MEMORANDUM

Subject: Ararimu Road Managed fill

Application #: BUN60425181 -

Figure 1. Stage 1 planting area

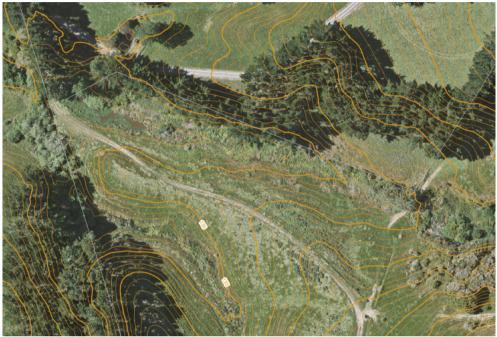
The area now omitted from the landscape mitigation planting lies between the gradually rising land between the watercourse and the foot of the proposed Stage 1 fil area, and at the eastern end of the small gully containing the aforementioned wetland. The gully in question is shown below in Figure 1 below.

The reduction in the width and length of this planted area will not diminish the mitigation offered when compared to the planting as proposed under the previous iteration. The ecologist is better qualified to comment on the ecological contribution of the planting, but in my opinion, the planting of the wetland and its riparian margins will still provide the landscape benefits previously described in my landscape assessment.

Figure 2. 1628B Ararimu Road

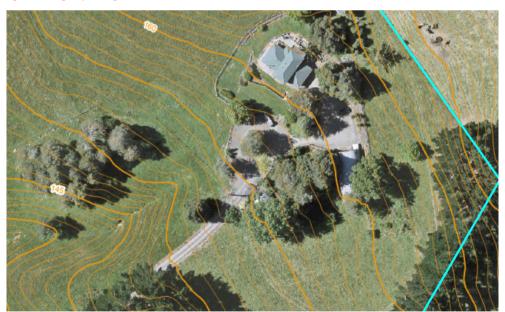
The boundary with the neighbouring property is defined by tall pine trees. As can be seen from the Figure above, these trees are located on the south facing gully side above the wetland. These trees, as well as the

proposed mitigation planting (which varies between 10 - 30m in width) contained within the gully, will buffer views from this adjoining property.

As mentioned above, the eastern end of the gully is no longer included within the landscape mitigation planting area. In addition to the pine trees, this portion of the gully (and the eastern edge of the subject Site) is screened by the rising landform to the north and north east. Views to this part of the Site will be screened from the neighbouring dwelling within 1628B Ararimu Road by the pine trees, the landform and a substantial cluster of trees located to the south of this dwelling — as shown in Figure 2 above.

Figure 3. Landscape mitigation planting SE boundary

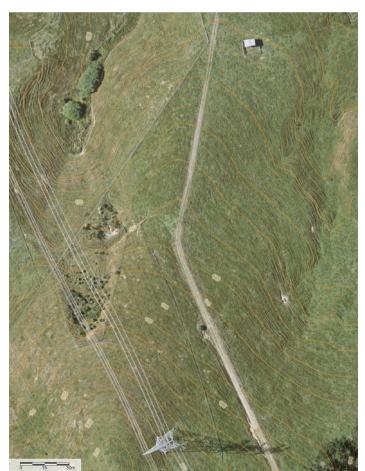
The RFI sought comment on whether any landscape effects would result in the accessway by the Transpower lines not being planted.

Comment: Previous RFI questions on this matter have focused on the matters such as potential edge effects resulting from the access. These, I understand have been addressed by the Ecologist. My response will focus on the landscape mitigation offered by the proposed planting on this south eastern edge of the Site.

This proposed area of landscape mitigation planting will, at its northern end, occupy a northerly trending spur crest before dog-legging to the south east where it will encompass the upper flanks of the spur, and run parallel to the Transpower lines (refer to Figure 3 at left). The area of revegetation will be substantial and will – in terms of its scale, location and species composition, reflect similar pockets of native remnant vegetation in the area which also occupy steeper gully and spur slopes.

The Transpower access will bisect this area of planting, but with a width of 3-4m, the access will be largely hidden from most viewpoints once the vegetation has become established.

Visually, therefore it will not detract from the mitigation objectives of the planting and the vegetation will 'read' as a natural native vegetation remanent.

As mentioned previously, the project Ecologist has confirmed that any edge effects resulting from the access can be managed. Overall therefore, I am of the opinion that the unplanted access will not detract from the landscape mitigation offered by this area of landscape mitigation planting.

1618 Ararimu Road, Papakura
FIGURE 2b: Landscape and ecological mitigation proposal
23017_02_02

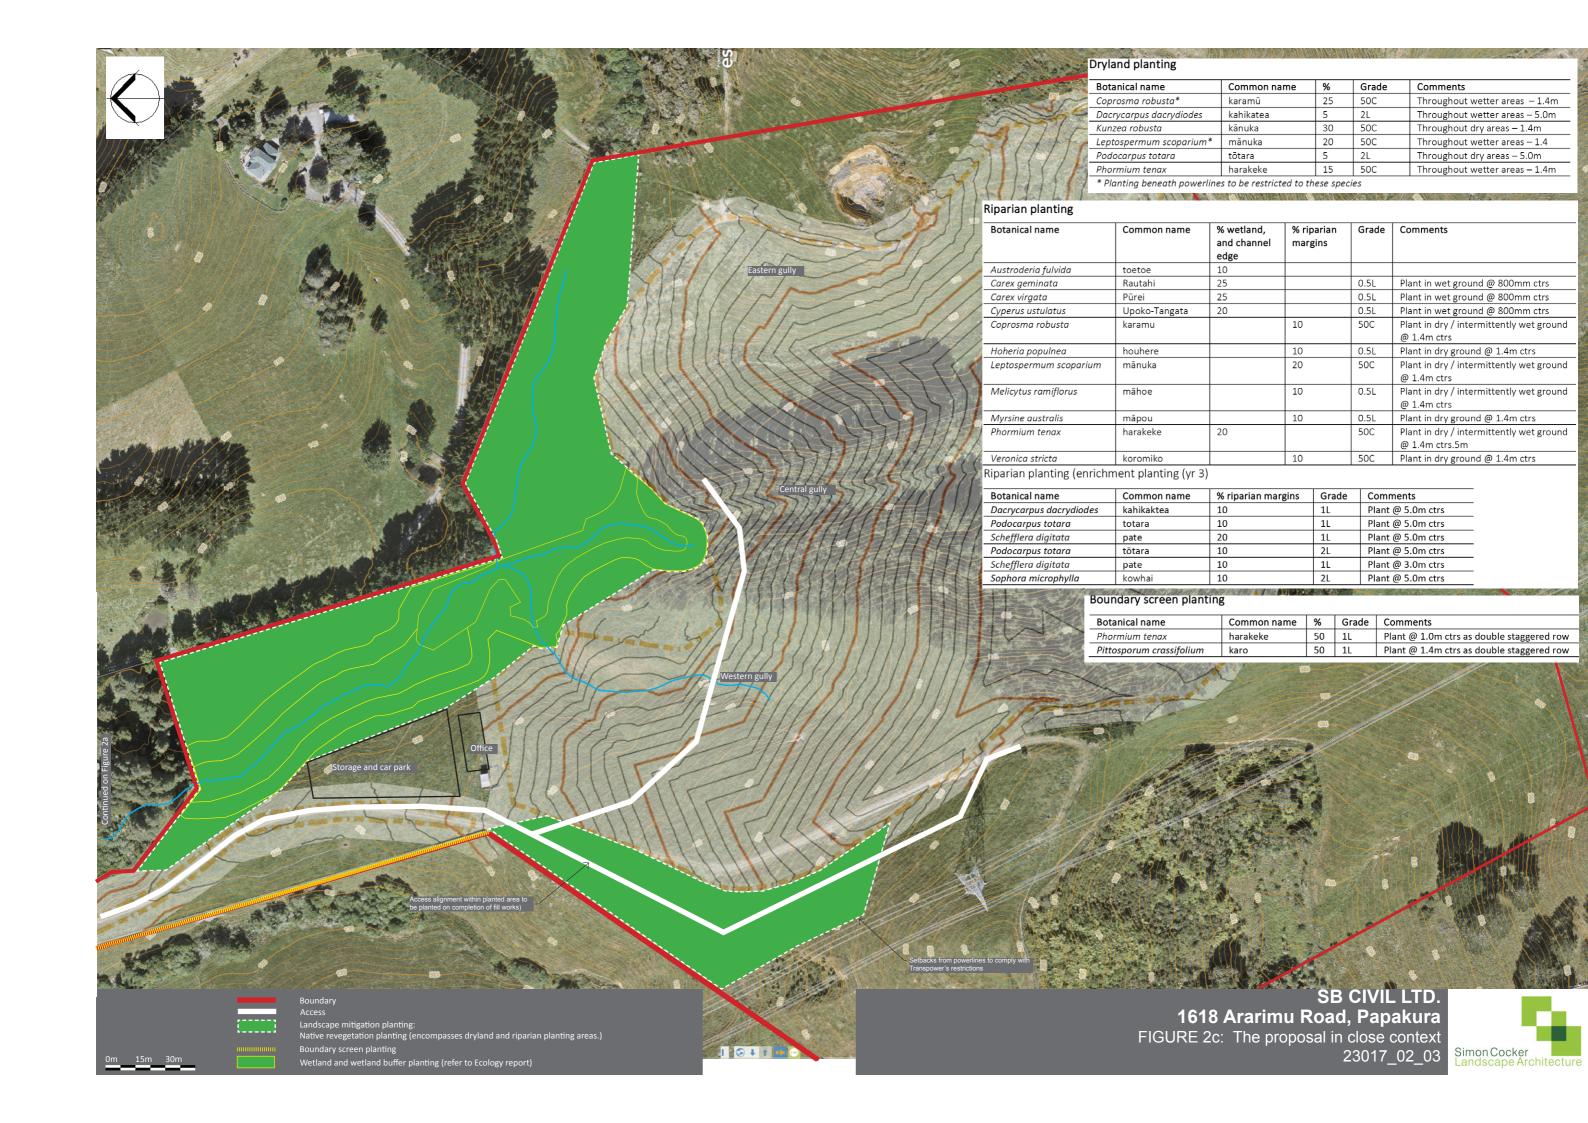
Items 4-6 and the updated landscape mitigation planting plans advise that the location, extent and width of proposed landscape and visual mitigation planting has changed. In addition, covenants will not be provided to provide long-term protection and pest and weed management for those areas and the access will not be planted on completion of the fill works. No explanation as to effectiveness of the amended planting for landscape and visual mitigation including its ecological contribution has been provided.

Please provide an explanation and comment from the Landscape Specialist (Simon Cocker) regarding the effectiveness of the amended mitigation planting now being proposed and also the inability to ensure long term maintenance and health of the planted areas. (This aligns with the outstanding matters in Items 51 and 55 of the s92 response Table).

Comment: For the purpose of clarity, It is understood that the plans being referenced are those contained in the updated SCLA landscape assessment (dated 27 September 2024 – Rev B), and the most recently supplied updated iteration (dated 3 April 2025). I have attached these plans to this memo.

The primary divergences between the 27 September 2024 – Rev B iteration and the 3 April 2025 iteration of the plans are as follows:

- 1. A minor refinement to the western edge of the landscape mitigation planting where it adjoins the car park / storage area and SRP. This will not result in any change in the mitigation offered by the proposed planting.
- 2. A reduction in the width and length of the finger of planting on the northern boundary of Stage 1. This area of planting has been reduced in width but still encompasses the watercourse and includes wetland and wetland buffer planting (as identified and specified by the project Ecologist).
